MONTGOMERY COUNTY HISTORIC PRESERVATION COMMISSION
STAFF REPORT

Address:	8 Primrose Street, Chevy Chase	Meeting Date:	4/20/2020
Resource:	Contributing Resource Chevy Chase Village Historic District	Report Date:	4/13/2022 4/18/2022
Applicant:	Justin & Kimberly Shur	Public Notice:	4/6/2022
Review:	Historic Area Work Permit	Tax Credit:	Partial
Case Number:	984993	Staff:	Dan Bruechert
Proposal:	Building Addition, demolition, door replacement, and skylight installation

Figure 2: 1927 Sanborn Fire Insurance Map.

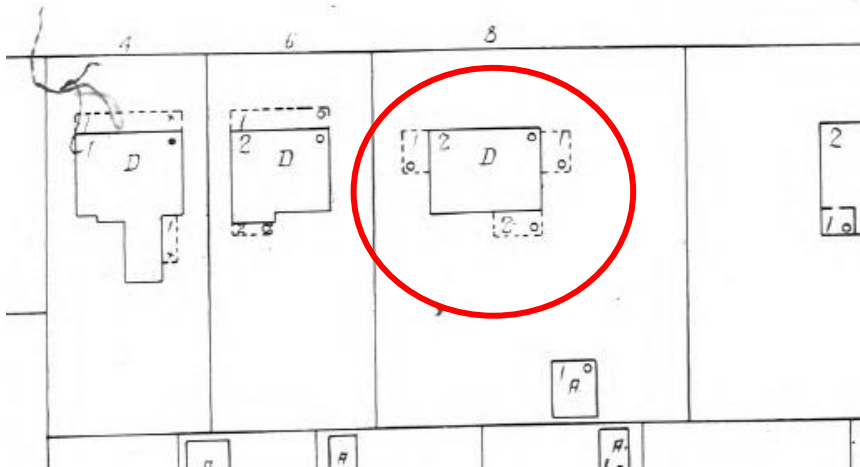
When the subject property was constructed, there were three open porches. Two one-story porches, one each to the east and west, and a second-story sleeping porch in the rear (see 1927 Sanborn Fire Insurance Map, below). At some point, the sleeping porch was enclosed in stucco to match the house finish and a bay window was constructed at the rear. The applicant proposes to modify the existing rear bay by raising its height and installing a flat roof. Additionally, the applicant proposes construct a new shed roof porch. On the second story, the applicant proposes to install three six-over-one wood sash windows and a pair of six-over-nine wood sash windows.

Staff finds that the alterations to the rear will not be visible from the public right-of-way and, under the *Design Guidelines*, are entitled to a very lenient review. Staff finds that the design and materials for the rear addition are compatible with the house and surrounding district and recommends approval under the *Design Guidelines* and 24A-8(b)(2) and (d).

Existing Window Survey 1

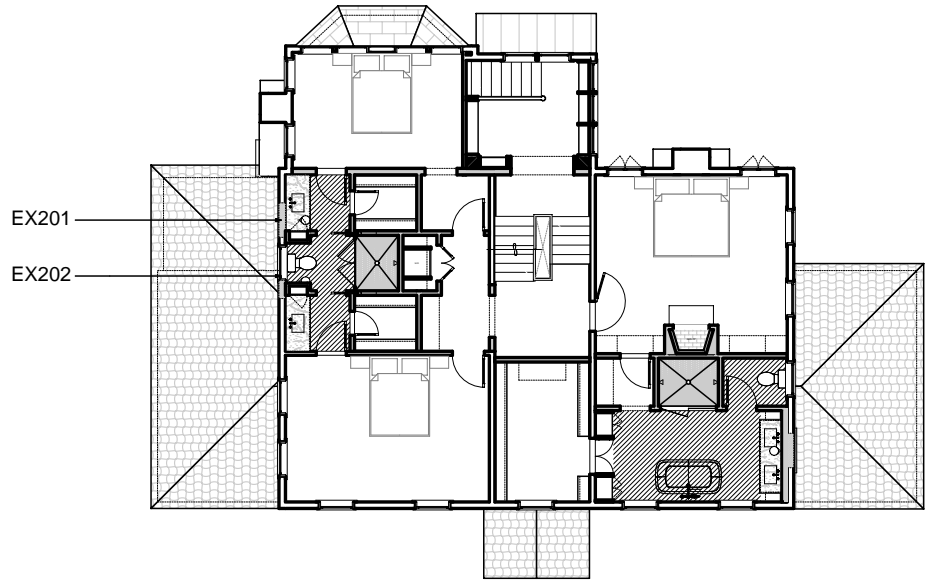
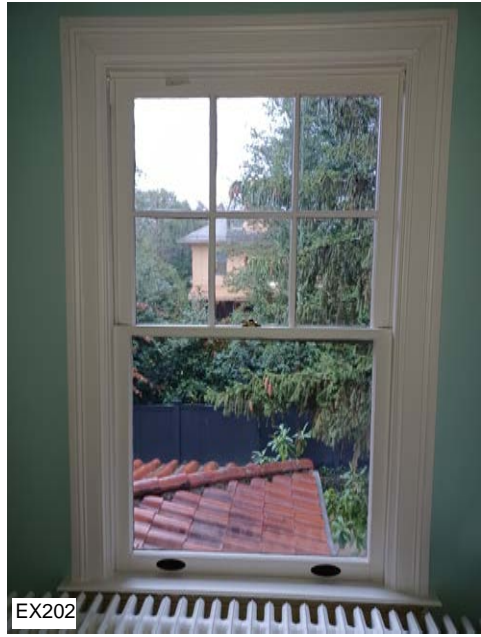
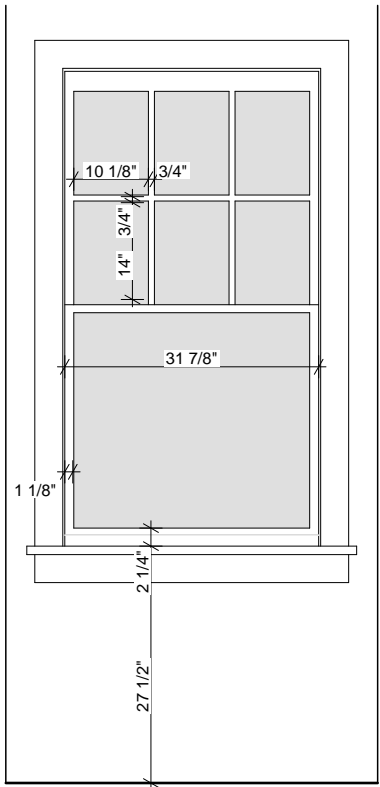
Based on the photographic evidence submitted, Staff finds the existing historic windows on the east elevation (labeled EX201 and EX202) appear to be in acceptable condition. As these windows are visible from the public right-of-way, their removal and replacement need to be reviewed under moderate scrutiny. Staff finds the proposed replacement window is an appropriately detailed wood window to be a compatible replacement for the historic windows at the subject property; the proposed windows match the dimensions and materials of the historic. The larger question is, whether it is appropriate to remove historic window openings and re-locate the openings. The historic house is a symmetrical design, five bays wide on the front and four bays deep on the sides. While removing one window opening on the east elevation and changing the window pattern, Staff finds that the proposal is acceptable on this elevation. Staff finds that while these two windows are visible from the public right-of-way (see Fig. 3), they are the third and fourth bay to the rear and are partially obscured by the porch roof. Because the windows are further removed from the streetscape with reduced visibility, Staff finds they are less significant than the windows closer to the front wall plane. Additionally, Staff finds that installing one window that matches the appearance of the historic and will not leave a blank wall plane and is an acceptable mitigating measure. Staff finds that with these windows removed and the new window installed, the house will still contribute to the district. Staff recommends the HPC approve the east window removal and replacement under the *Design Guidelines* and 234A-8(d).

Existing Window
Survey 2

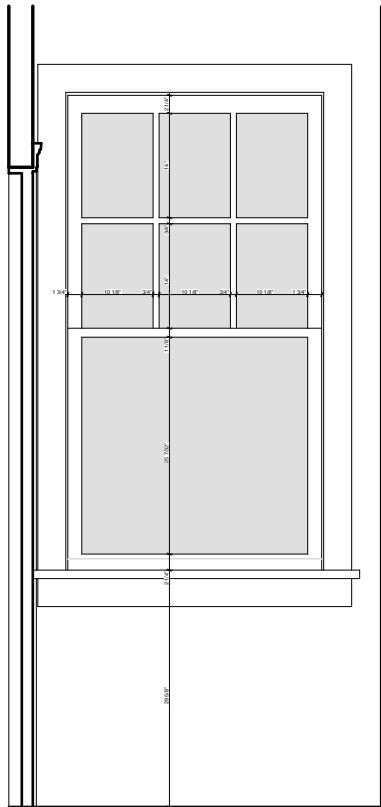
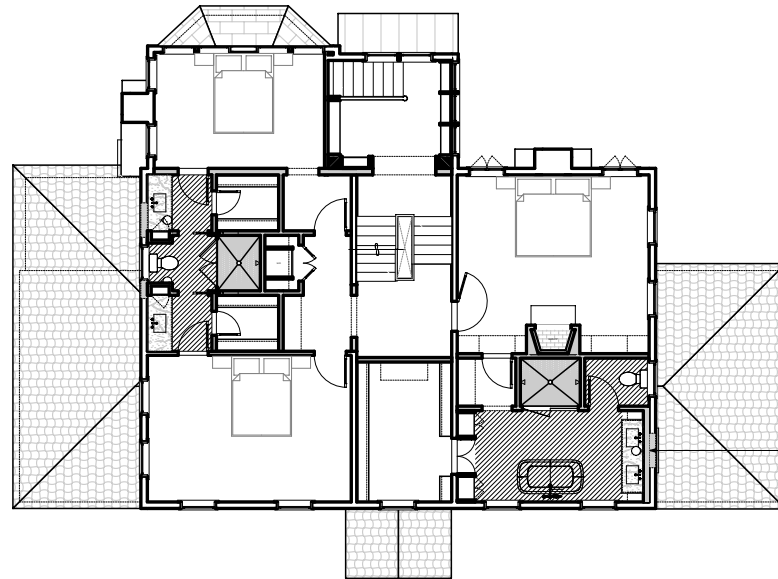
While Staff recommends approval for the window replacement on the east elevation, Staff cannot recommend approving the removal of the window on the west elevation, EX211, the window's shutters, and fixing wood shutters over the blocked-in opening. Window EX211 appears to be in good working order and, it appears to Staff, that the window removal is driven entirely by changes to the interior plan. The proposal places a new sink and vanity in front of this window opening. Staff supports retaining this window for several reasons. Staff notes that proposed changes in the Chevy Chase Village are to be evaluated on how they are viewed from the right-of-way. This requires a stricter application of the approval criteria closer to the front of the house. First, this window is closer to the front of the house, so its removal will have a larger impact on the character of the house and will disrupt the even window spacing on the right elevation (see the elevation drawings below). Second, Staff finds that even though the shutters will be retained, their fixed closed configuration coupled with the loss of the historic window will negatively affect the design and material integrity of the house. Under a moderate scrutiny review, the HPC needs to take preserving the integrity of the resource into consideration. Staff finds that the window and shutters are both original to the house construction and their removal would negatively impact that integrity. Staff acknowledges that the house would likely still contribute to the surrounding streetscape; however, the change is not compatible with the original design of the house. Staff finds the removal of window (EX211) does not satisfy the requirements of "Moderate Scrutiny" in the *Design Guidelines* and does not comply with 24A-8(b)(1) and (2). Staff recommends the HPC add a condition to the approval of this HAWP that retains window EX211 in place with the existing shutters. The HPC should delegate final approval authority to Staff to verify that this condition has been satisfied upon the applicant's submission of the final permit drawings.

1. The window on the second story on the west elevation (EX211) needs to be retained. Final approval authority to ensure the condition has been satisfied is delegated to Staff;

1 Existing Right Elevation
1/8" = 1'-0"

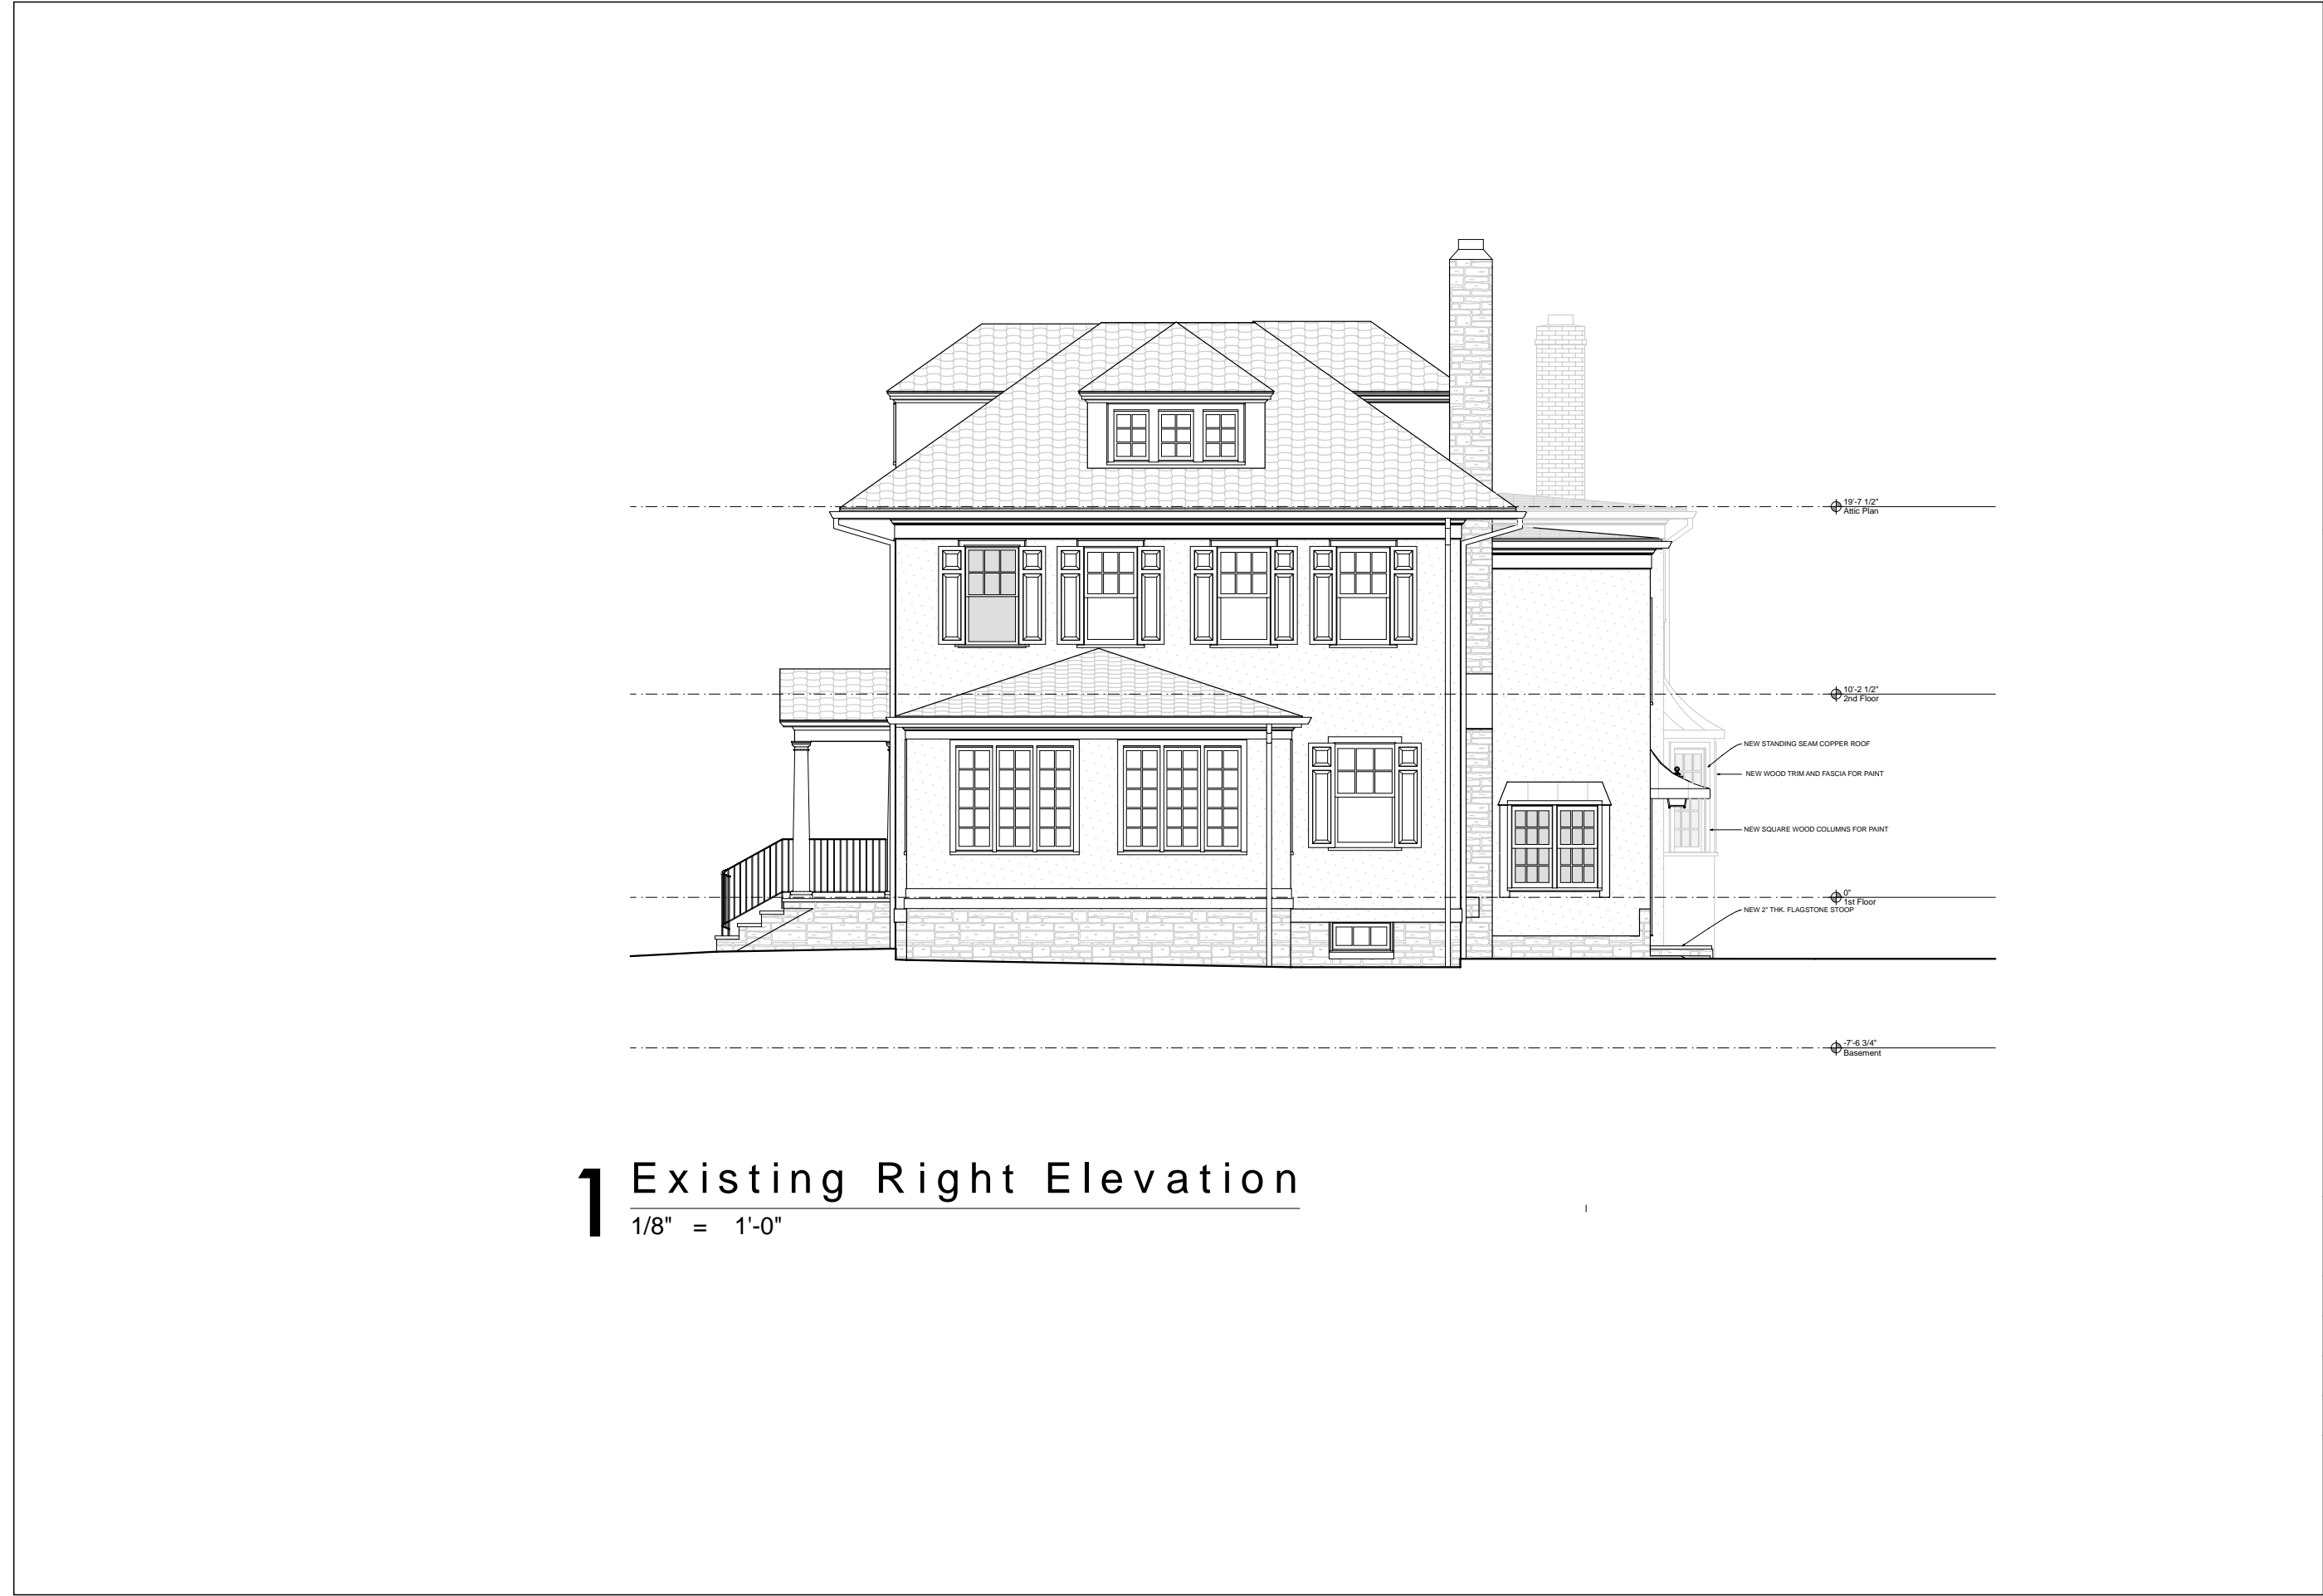
The applicant proposes to alter the fenestration on the side and rear elevations. On the right (west) elevation, the applicant proposes to remove the six-over-one wood sash window in the second floor opening closest to the front wall plane (labeled EX211 in the plans), block in the opening, and retain the shutters in a permanently closed position. On the second floor of the left (east) elevation, the applicant proposes removing the two rear six-over-one sash windows (EX201 and EX202), patching the walls, and installing a single wood six-over-one sash window. On the rear elevation, the applicant proposes to remove the first-floor casement windows on either side of the chimney and install a much larger pair of
